UNITED STATES PATENT AND TRADEMARK OFFICE

APPLICATION NO.	FILING DATE	FIRST NAMED INVENTOR	ATTORNEY DOCKET NO.	CONFIRMATION NO.
10/762,228	01/21/2004	Scott Fast	0739D-000104	2198
27572	7590	09/28/2005	EXAMINER	
HARNESS, DICKEY & PIERCE, P.L.C.			EDEL, JOSEPH F	
P.O. BOX 828			ART UNIT	
BLOOMFIELD HILLS, MI 48303			PAPER NUMBER

Office Action Summary

Diagram A - Annotated Figure 3 of Croft

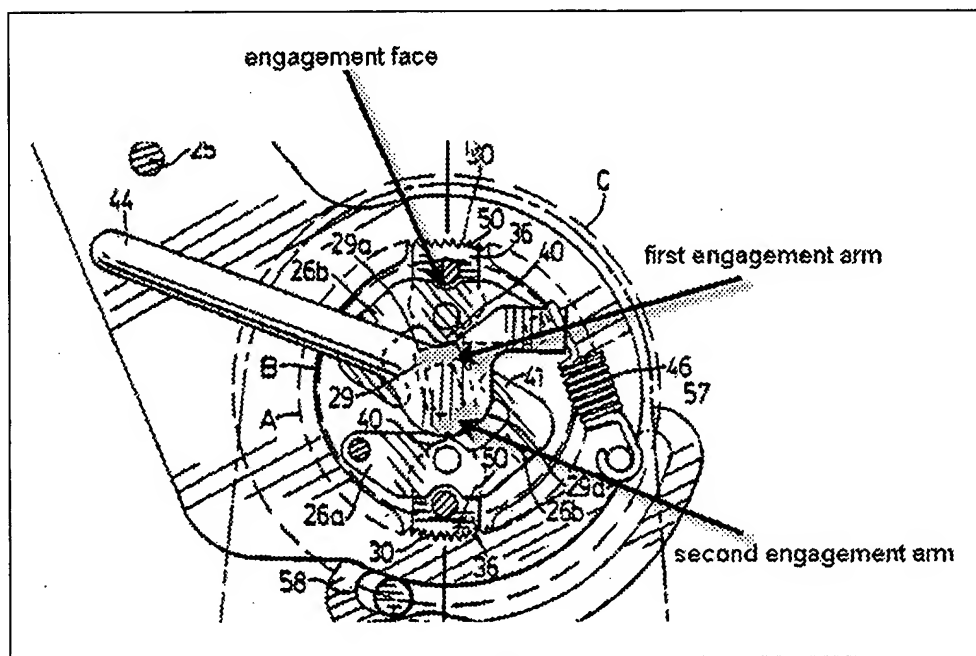
Croft discloses a recliner assembly that includes all the limitations recited in claims 1-3, 6-11, 18, and 22-25. Croft shows a recliner assembly having a first housing plate 33 (see Fig. 2), a second housing plate 23 rotatably support by the first housing plate, first and second pawls 36 that are each movable between a locked position engaging the second housing plate to prohibit rotation of the second housing plate relative to the first housing plate and an unlocked position disengaged from the second

housing plate to enable rotation of the second housing plate relative to the first housing plate, first and second locking cams 26 that are each rotatably supported by the first housing plate, a main cam 29 rotatably supported by the first housing plate, a biasing member 46 acting on the main cam to bias the main cam into engagement with the first locking cam to thereby urge the first pawl into the locked position, an engagement face (see Diagram A below) of the first locking cam that is formed at an angular relationship with the first pawl, first and second engagement arms/extensions (see Diagram A below) of the main cam, a gap disposed between the first and second pawls and the main cam when the first and second pawls are in the locked position, and first and second arms 42,43 of the first pawl with a recess formed therebetween wherein the recliner assembly is supported by a seat bottom and back configuration, the first pawl is operable to apply a primary force to the second housing plate in a locked position with a first force component normal to the engagement of the pawl and the second housing plate and a second force component perpendicular to the first force component, the locking cams are operable to engage the pawls to urge the pawls into the locked position in response to rotation of the main cam, the main cam is operable to selectively rotate the first locking cam into engagement with the first pawl to urge the first pawl into the locked position, the engagement face is operable to selectively receive the first pawl and to apply the primary force to the first pawl at an angle between 14-22 degrees, the first engagement arm of the main cam is in contact with the first pawl to selectively toggle the pawl between the locked and unlocked positions and the second engagement arm is positioned at a predetermined distance from the first pawl when the

first pawl is in the locked position, the gap is operable to allow interaction (via the locking cams) between the first and second pawls and the main cam to further lock the first housing plate to the second housing plate when a predetermined load is applied to the seat bottom or the seat back, the first locking cam is operable to engage the first arm of the first pawl to urge the first pawl into the locked position, and the second arm/extension of the locking cam is spaced a distance from the second arm of the first pawl when the first pawl is in the locked position.
